Title - Sujet Greenstone Yellowknife	
Solicitation No. - N° de l'invitation EW038-180666/A	Amendment No. - N° modif. 009
Client Reference No. - N° de référence du client PPSC - EW038-180666	Date 2017-08-18
GETS Reference No. - N° de référence de SEAG PW-\$PWU-023-11140	
File No. - N° de dossier PWU-7-40065 (023)	CCC No./N° CCC - FMS No./N° VME
Solicitation Closes - L'invitation prend fin at - à 02:00 PM on - le 2017-08-22	Time Zone Fuseau horaire Mountain Daylight Saving Time MDT
F.O.B. - F.A.B. Plant-Usine: <input type="checkbox"/> Destination: <input type="checkbox"/> Other-Autre: <input type="checkbox"/>	
Address Enquiries to: - Adresser toutes questions à: Taylor (RPC), Ian	Buyer Id - Id de l'acheteur pwu023
Telephone No. - N° de téléphone (780) 566-9487 ()	FAX No. - N° de FAX (780) 497-3510
Destination - of Goods, Services, and Construction: Destination - des biens, services et construction:

1.1 ADDENDUM FORM

Drawing Title
ACOUSTIC CEILING BAFFLE

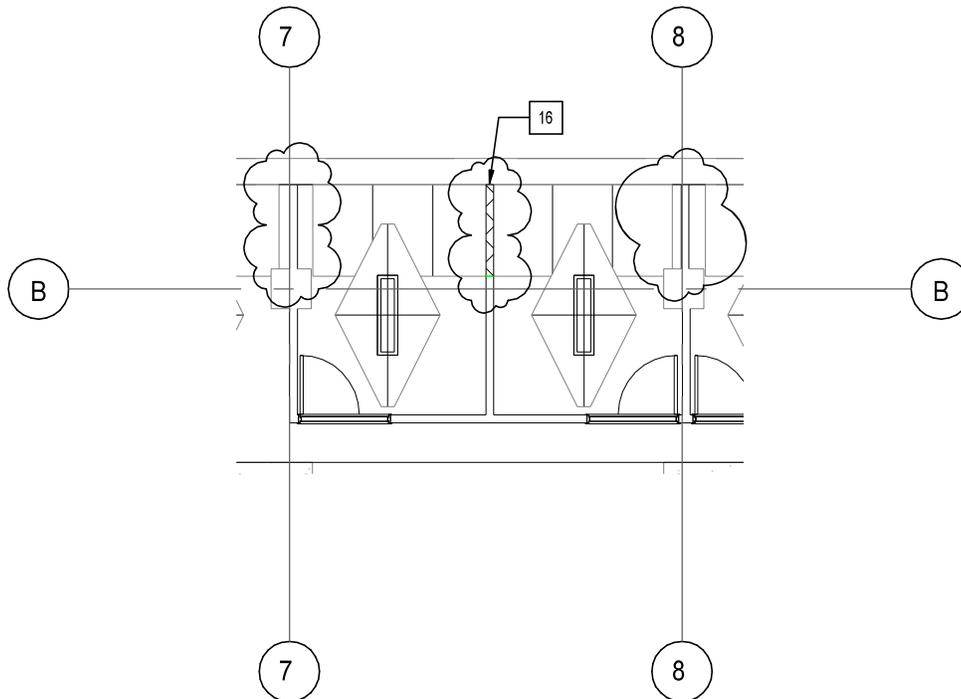
- .1 DRAWING ID2.1 – 4th FLOOR CONSTRUCTION PLAN
 - .1 Refer to plan 3 on Sheet ID2.1 – Partial 4th Floor Reflected Ceiling Plan; revise according to acoustic ceiling baffle detail drawing AD1.6 as attached to this addendum. **Delete** Keynote 16 at all gridlines. Keynote 16 refers to the portion of the wall between grid line B and the exterior wall where the concrete ceiling height changes.

- .12 Keynotes 16/ID2.1 calls for acoustic quilt above existing acoustic treatment. It appears that rooms 412-417 are exposed structure ceilings with one hanging cloud in each of them. Is the referenced note a discrepancy in regards room 412-417.

- .1 See attached drawing revision.
